# Final Commissioning Report For Eastmont High School

October 2015

## Commissioning Issues List

### Project: Eastmont High School

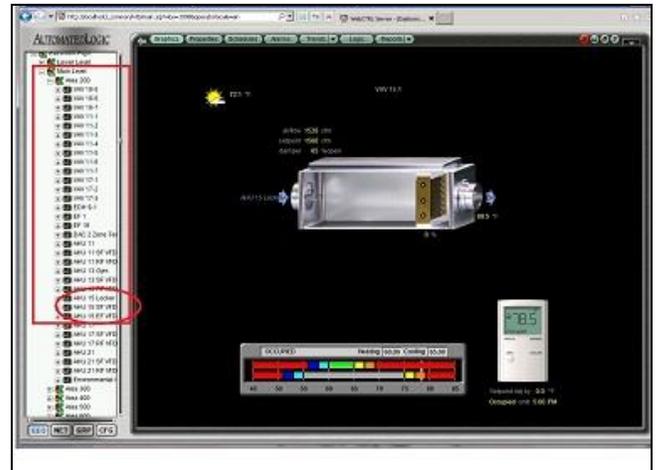
Issue ID #M-01 –Bad Air Flow Sensor

Issue ID # M-05—Exhaust duct is open

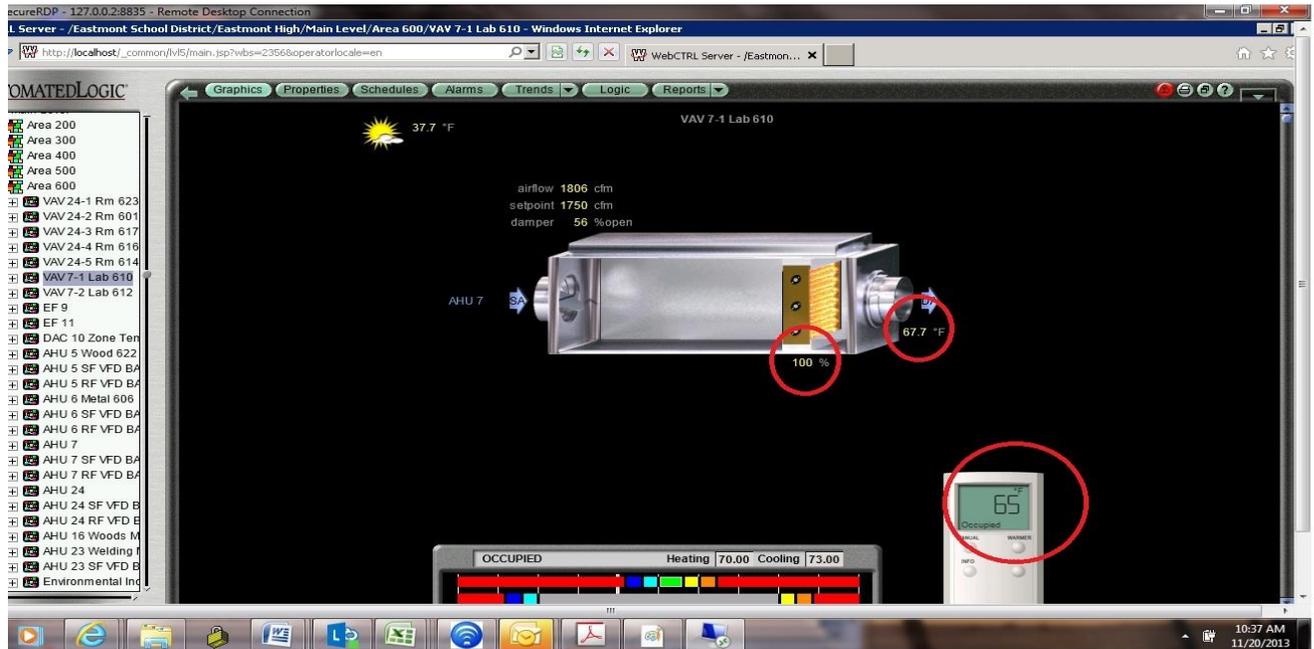
Issue ID #M-08—T-stat reading +4°F

Issue ID #M-013—Equipment Tree

Issue ID #M-19—Fume Hood Alarm’s are not powered or available to provide an audible alarm to an end user in case of airflow failure across the hood sash.

Issue ID #M-23—Missing Filters—AHU-14

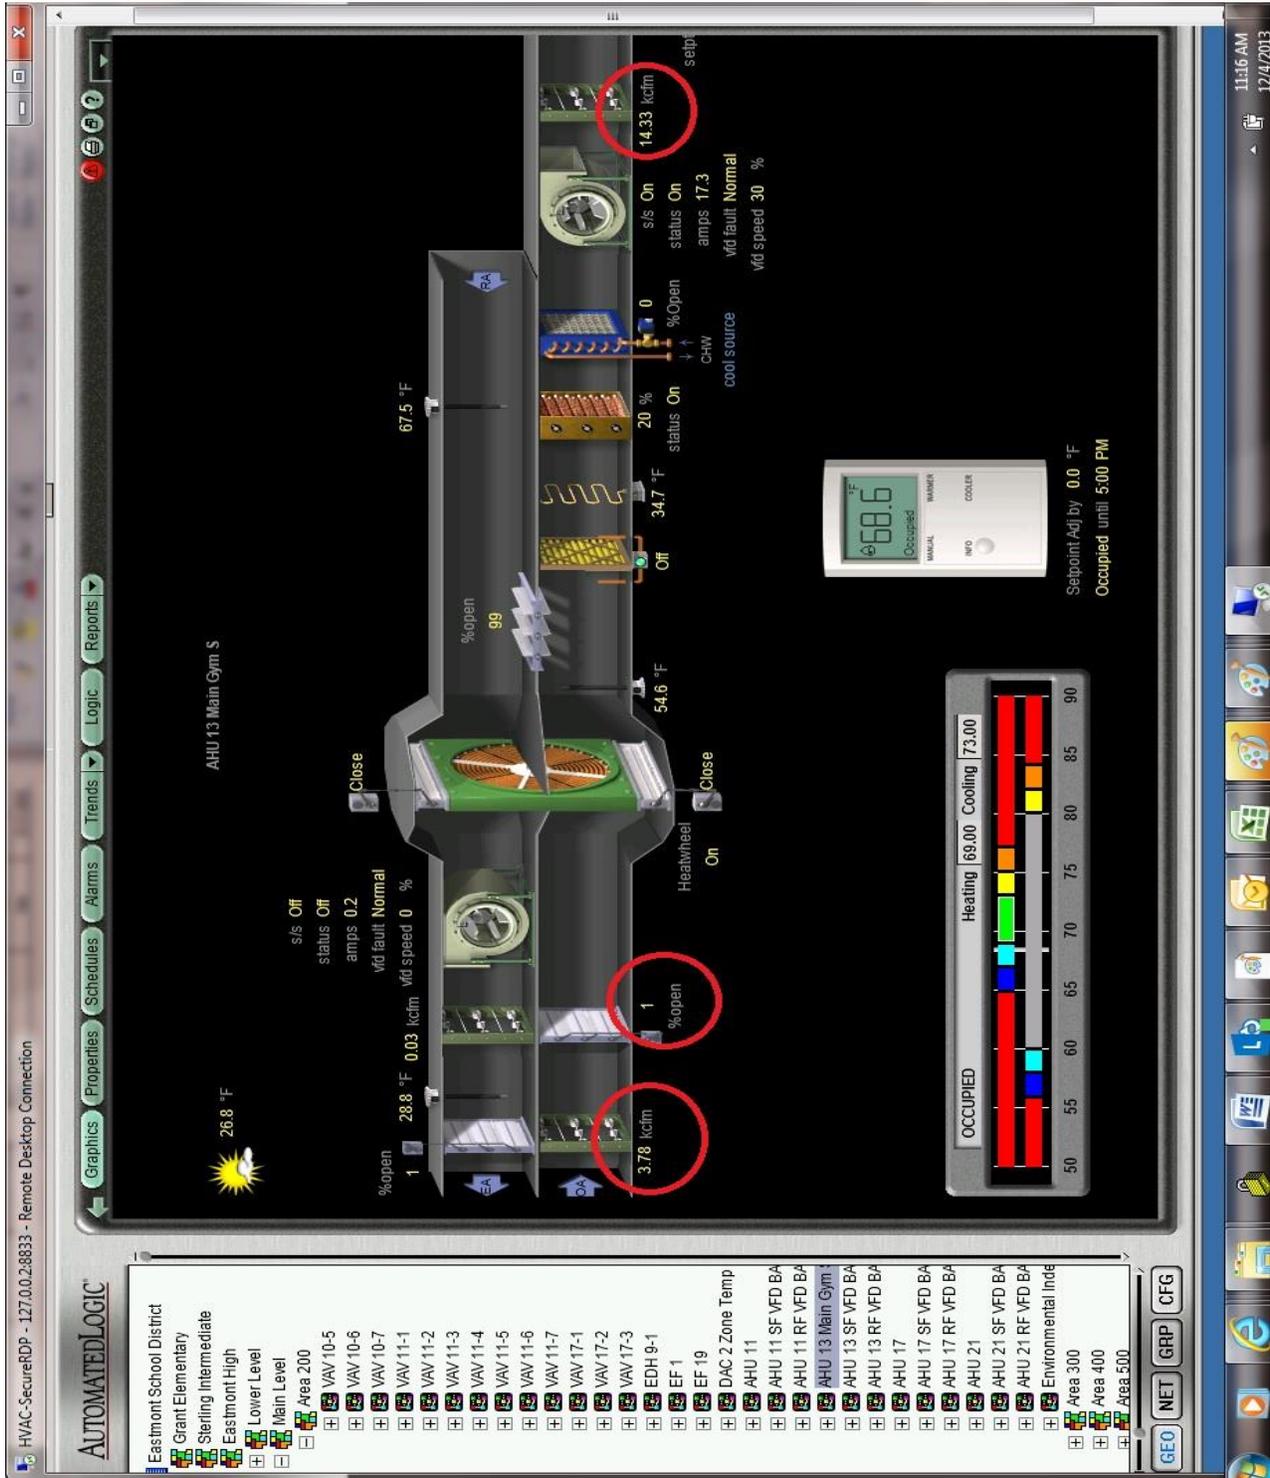
Issue ID #M-063—MAU-AHU-16 serving the Woods Shop was not running.

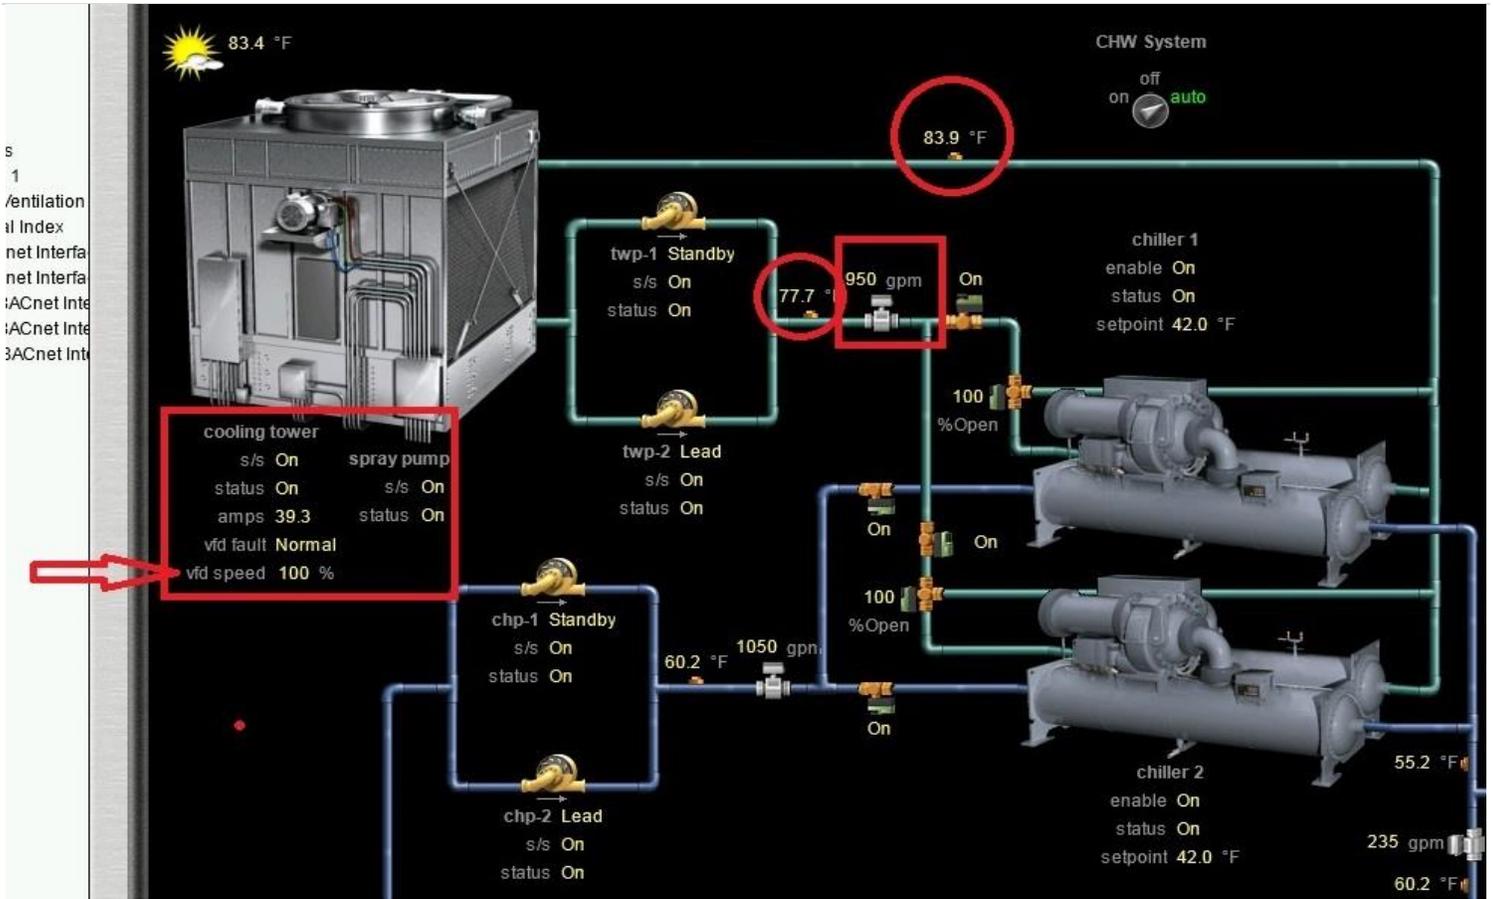
Issue ID #M-069—Although all fans are off, the static pressure within the duct is still being reported at 1.3”.

Issue ID #M-072—Airflow stations not measuring accurately. The supply air reading surpasses both design air for the unit as well as what’s reported in the TAB report. With OSA damper essentially closed, there should not be 3780 CFM at the flow sensor.

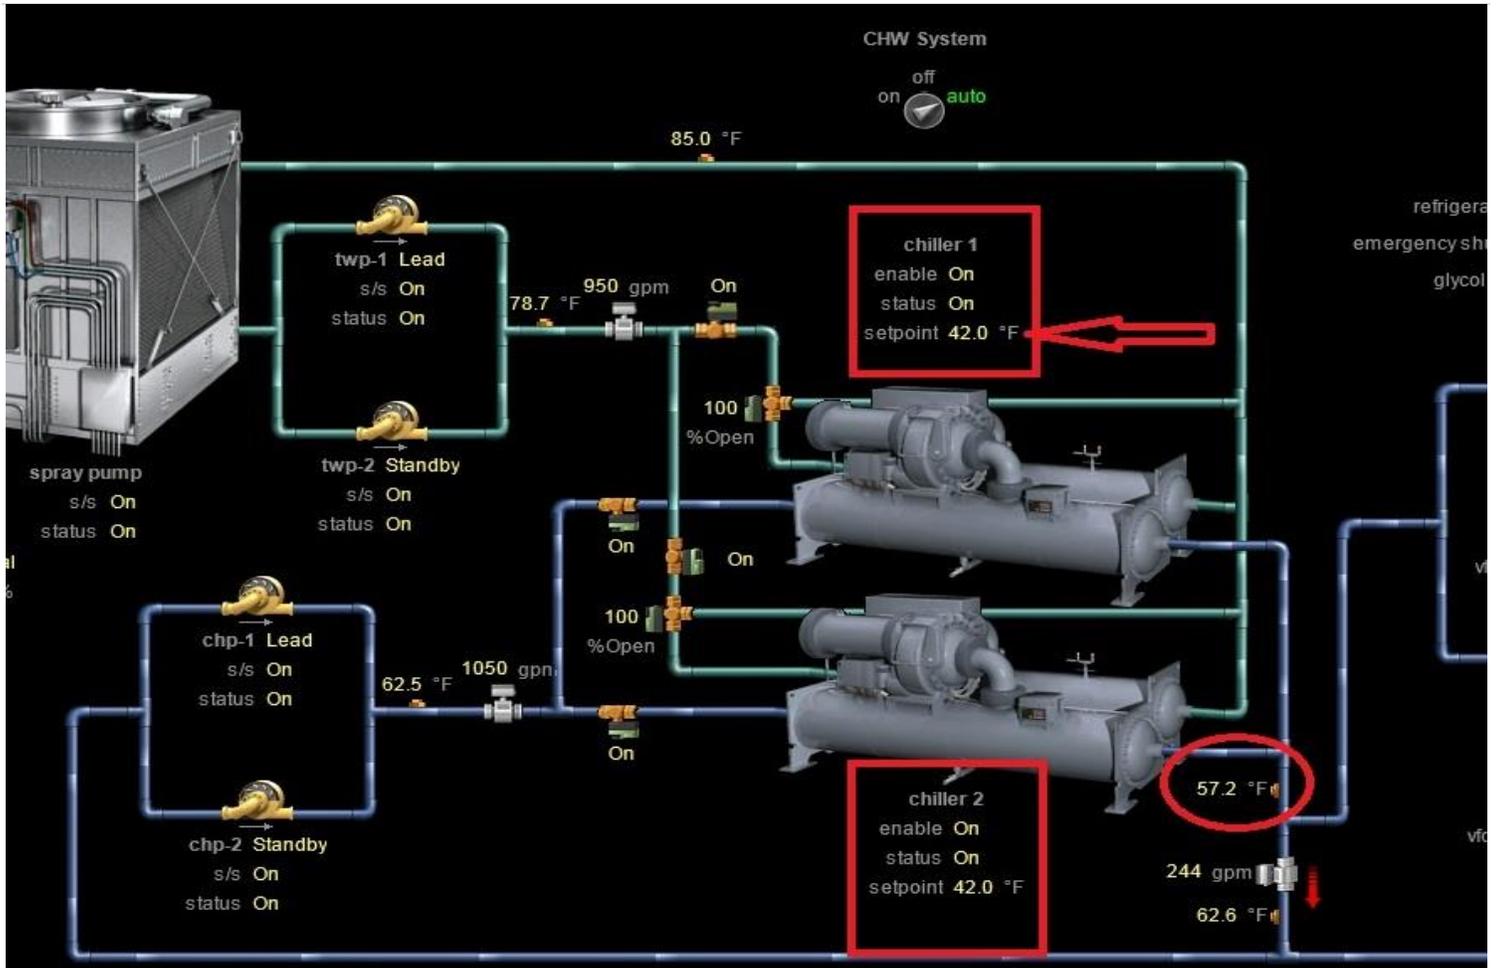
Issue ID #M-078— At 10:30 AM, the return air temperature from the space is only at 55.4°F indicating the space temps are extremely low throughout the entire 700/800 Areas. Of even more concern is the lack of ventilation air to occupied spaces because the lack of space temps keeping the AHU in Morning Warm up mode. Both issues violate WAC requirements for schools.

Issue ID #M-97—EF-18 has a failure. Commanded to run but is not capable.

Issue ID #M-98—Cooling tower performance does not appear to match the manufacturer’s performance data. A 6°F delta T at 100% capacity at only 83°F ambient temperatures seems low. The flow rate does not match the design. It is unknown what the wet bulb temperature is, what the air flow and spray water flow is at this time but that data should be provided in order to determine why it is underperforming. The design indicates a delta T of 10°F with a leaving fluid temp of 85.5°F. Here, the entering fluid temp isn’t even 84°F. It seems as though this system is wasting energy by operating at 100% capacity to get a 6°F delta T with entering and leaving fluid temps below the design. The cooling tower loops requires additional tuning to provide the most efficiency.

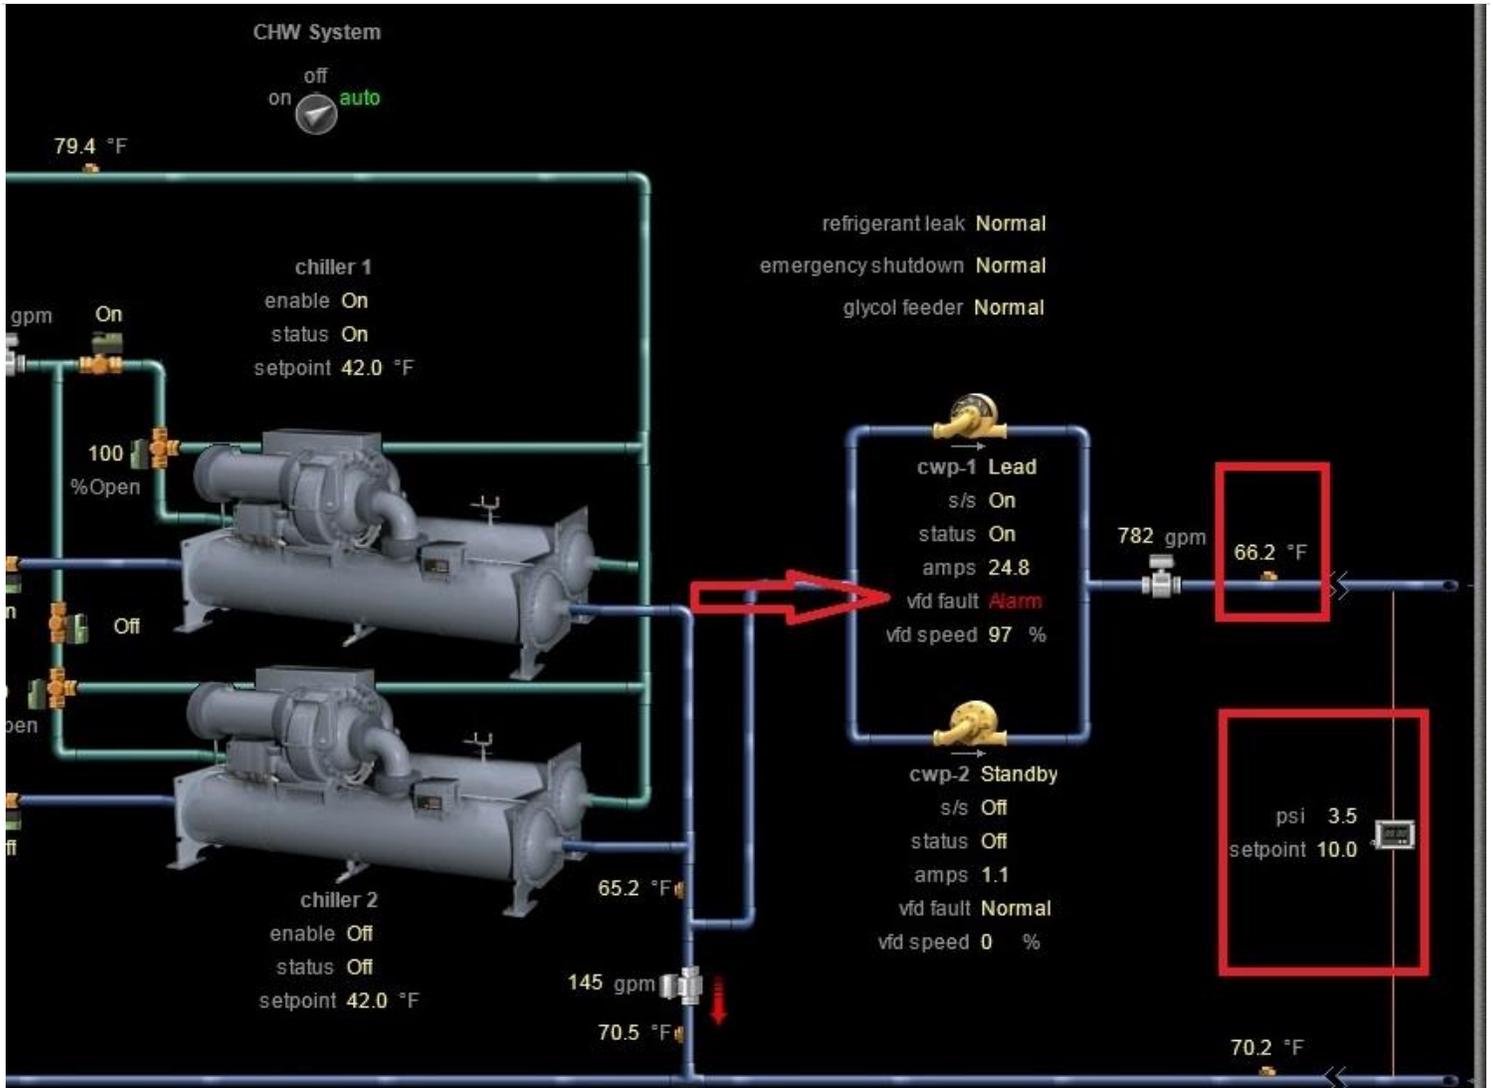
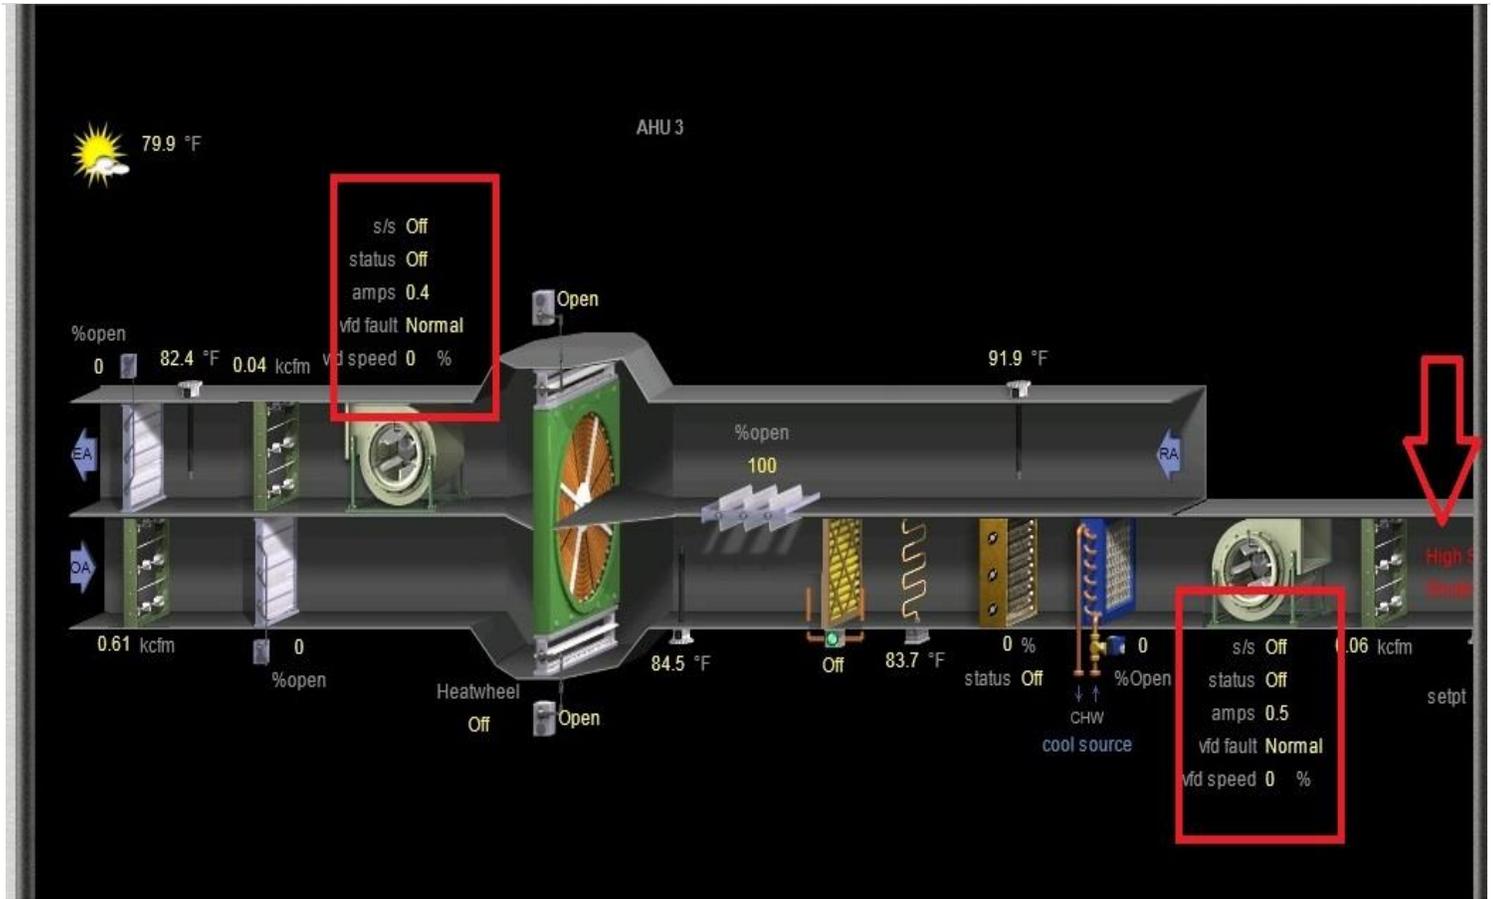
Issue ID #M-99—the chilled water loop temperature is unable to meet the set point of 42°F. Even with both chillers operating, the leaving water temperature is only 57.2°F and slightly warmer in the actual secondary loop after the circulation pumps. Because the Bacnet interface for both chillers is not yet completed, we are unable to determine whether the chillers were operating at full capacity. But in either case, there appears to be an issue that it is operating at 15°F above the loop set point. None of the AHU's are able to meet their respective discharge air temperature set points either and are operating with their CW control valves wide open. I am unable to access trends at the moment, but reviewing operations for the previous 4 days indicates the system has yet to meet the loop setpoint at all. In the diagram below, note the loop temperature is up to 66.2°F which offers very little cooling capacity.

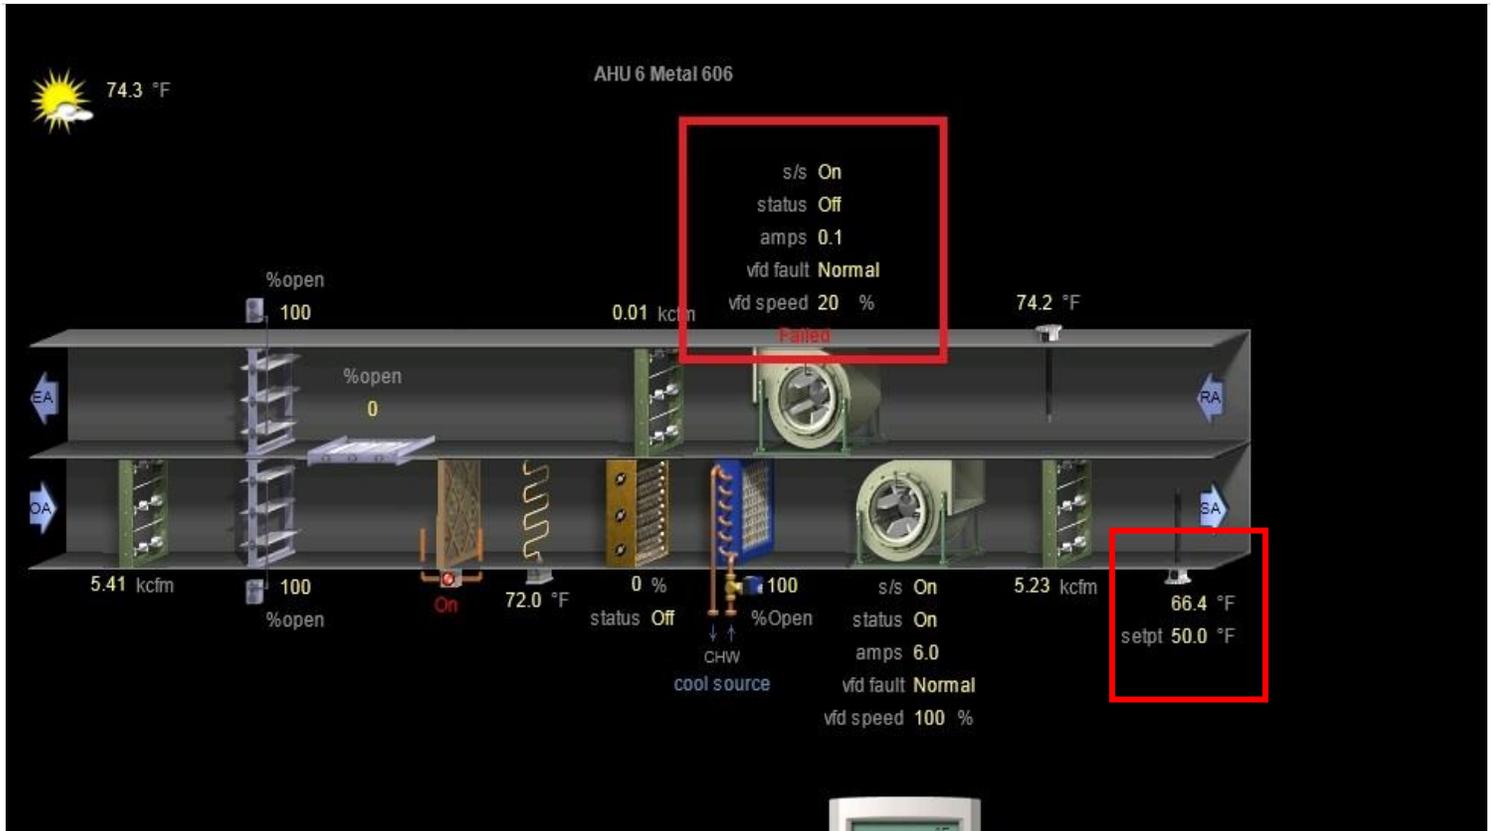
Issue ID #M-100—The CWP-1 VFD is in alarm. The CW loop differential pressure set point is not being met. Here the dP is 3.5 psi with a set point of 10 psi. CWP-2 is still on standby and should be cycling on to help increase water flow. Runtime is significantly higher for CWP-1 indicating lead / lag operation may not be working correctly. Trend data is not accessible at this time.
